RENESAS TECHNICAL UPDATE

Product Category	MPU/MCU		Document No.	TN-RX*-A142A/E	Rev.	1.00
Title	Addition of G Version (Ambient Temperature Range: -40 to +105°C) to RX64M Group		Information Category	Technical Notification		
Applicable Product	RX64M Group	Lot No.	Reference Document	RX64M Group User's Manual: Hardware (R01UH0377EJ0100)		
		All lots

The following amendments and additions related to the G version (ambient temperature range: -40 to +105°C) will be made to RX64M Group User's Manual: Hardware.

Figure 1.1 How to Read the Product Part Number

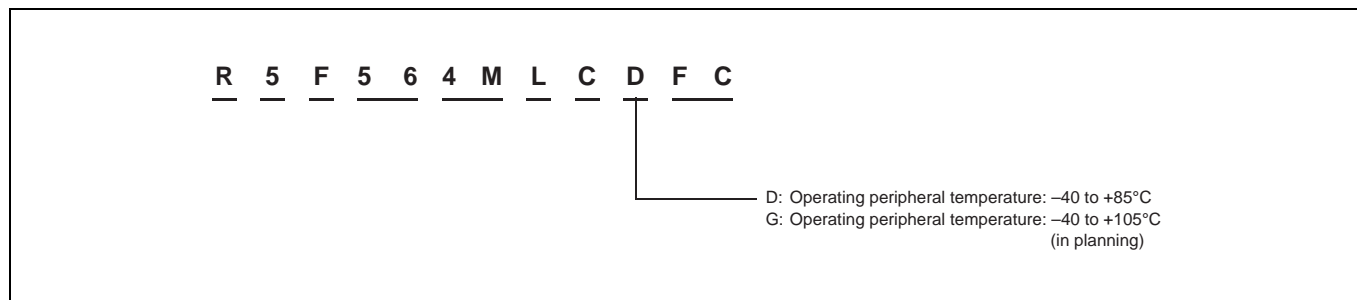
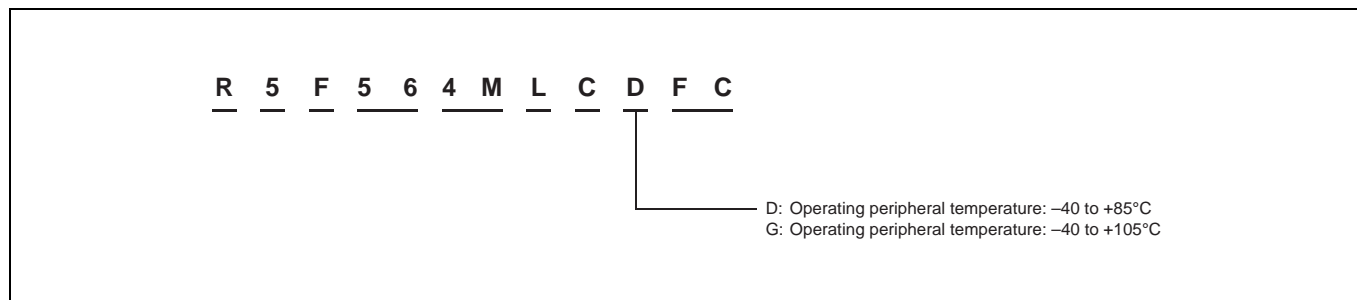
3. Figure 1.1, How to Read the Product Part Number, in 1.2, List of Products, will be amended as follows.
